**ISSUED:** January, 1999

**SUBJECT:** Rich Running Engines Above 7,000 Feet

**MODELS OR TYPES AFFECTED:** HM, HMSK, OHSK

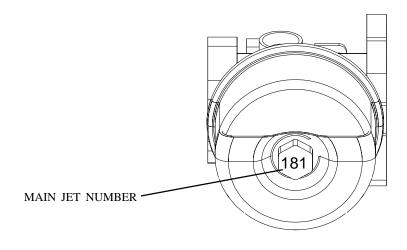
The main jets are identified with a stamped in number on the bottom (see illustration). Using the chart below select the correct service jet kit. The kit will include instructions, jet(s) and a bright colored decal advising the customer that the unit has been re-jetted to compensate for high altitude. The decal will further advise the operator to have the unit re-jetted if taken out of that range.
